### MEMORANDUM

**To:** The Design Advisory Board  
**From:** Mary O'Neil, AICP, Senior Planner  
**RE:** ZP 13-1262 CA/MA; 256-258 and 260-262 North Winooski Avenue  
**Date:** July 9, 2013

**Request:** Combine 256-258 and 260-262 North Winooski Avenue; demolish all buildings, construct 2 new connected three story buildings with a total of 23 residential units and 1 commercial unit. Parking for 23 units will be provided on-site. A two-space parking waiver is requested toward the commercial use, which at this time is proposed to be a restaurant. A shared access drive with the abutting property (264 North Winooski Avenue, Legal Aid) is included, with a companion application.

SITE  
 PLAN

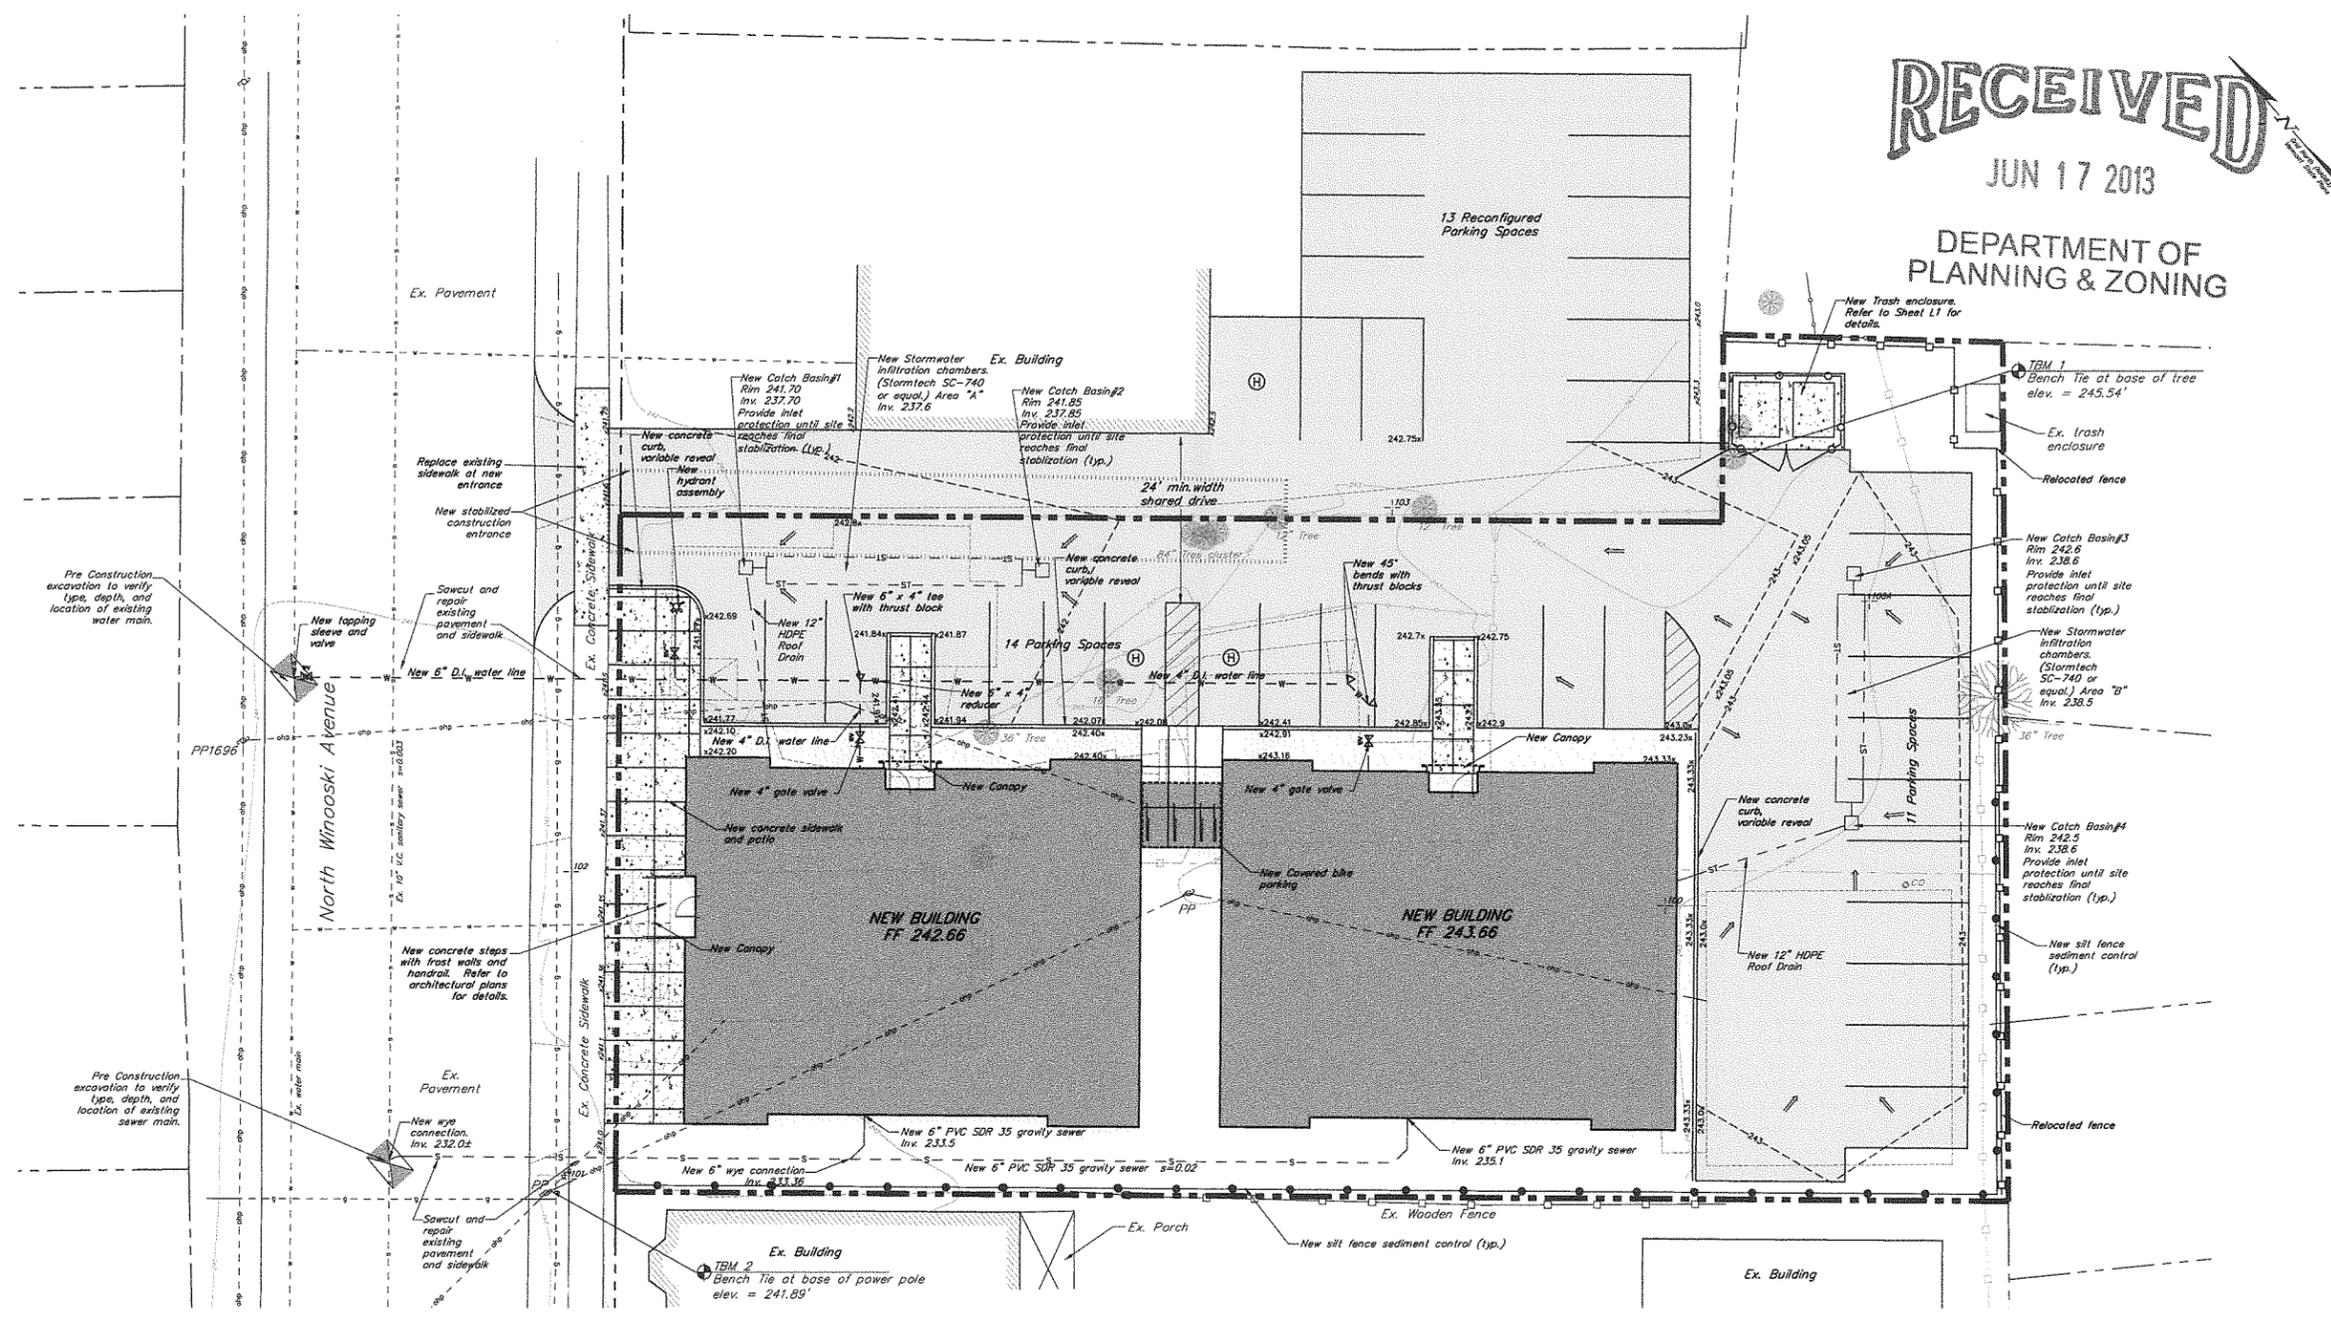
Direct pedestrian access is proposed from both the public sidewalk and the parking area on the east. There is no physical separation between pedestrian walk areas and the parking lot, although much of the parking directly abuts the building. A method of safe separation should be considered and developed. At Technical Review, a sidewalk access was recommended between the parking lot and the front entrance, to address the likely “desire path” that would occur over proposed green space at that location. Revised site plans show pavement connection reflecting that recommendation.

For 25 parking spaces, 5 shade trees meeting the caliper size specified will need to be provided to meet this standard. 8 trees are illustrated in immediate proximity to the parking areas, meeting this provision. Replacement fencing is proposed along the rear (east?) property line to shield neighboring properties from headlight glare.

There is no identified walkway that separates vehicles and pedestrians within the circulation areas of the parking lot. The entrances, however, are visually clear and evident for building entrance. It may be prudent to articulate a small pathway for resident use on the east elevation along the front of the parking areas leading to entrances to minimize pedestrian/vehicular conflict. DPW has recommended a paved path between the parking area and the front entrance, to anticipate the "desire line" of traffic from the parking lot to the main entrance. This is illustrated on revised site plans.

PROJECT NORTH  
ROOF PLAN - WEST & EAST BUILDINGS  
Scale: 3/16" = 1'-0"

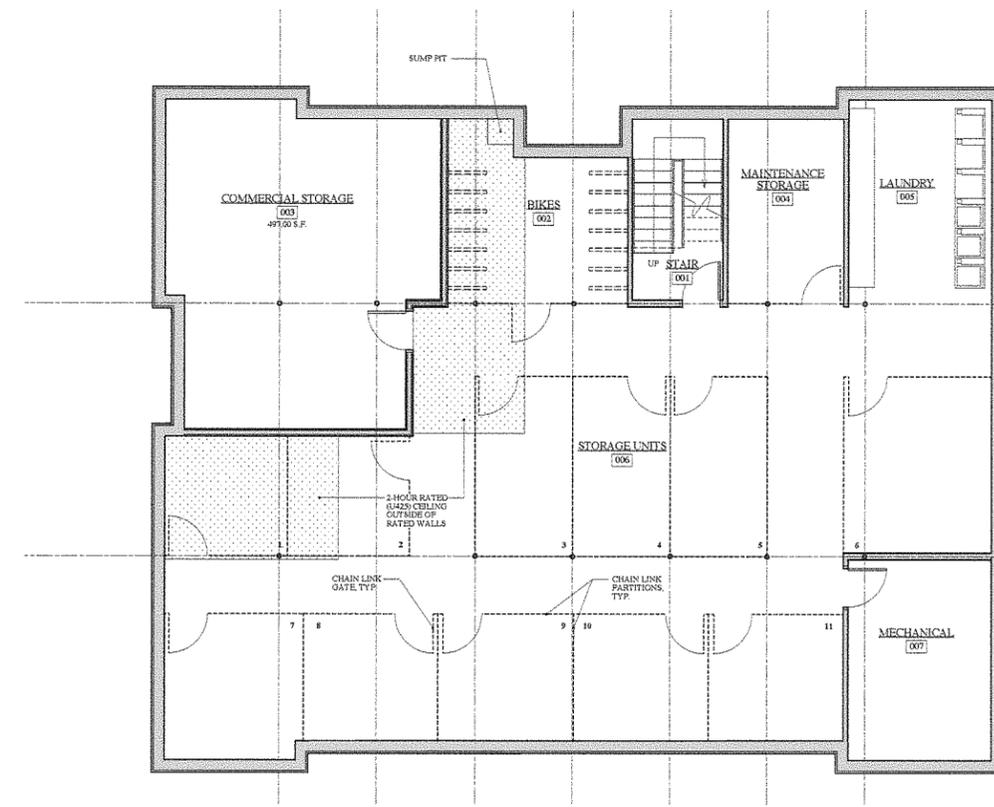
A cluster of condensing units/heat pumps is proposed for <10% of the roof area, meeting an exemption from the height limitations of Article 4. The applicant prefers roof mount of mechanical systems rather than ground mount due to the danger of vandalism and the likelihood of audible impact to residents. With a proposed 36" height screen intended to match the proposed siding material, the visual intrusion is likely to be minimized.

A working roof is proposed, with 40 solar panels proposed for each building roof. These are photovoltaic units, net metered (power directly to the grid) which makes them exempt from local zoning review per state statute. A "white" roof has been suggested as well by the applicants, in an effort to provide a "cool" roof.
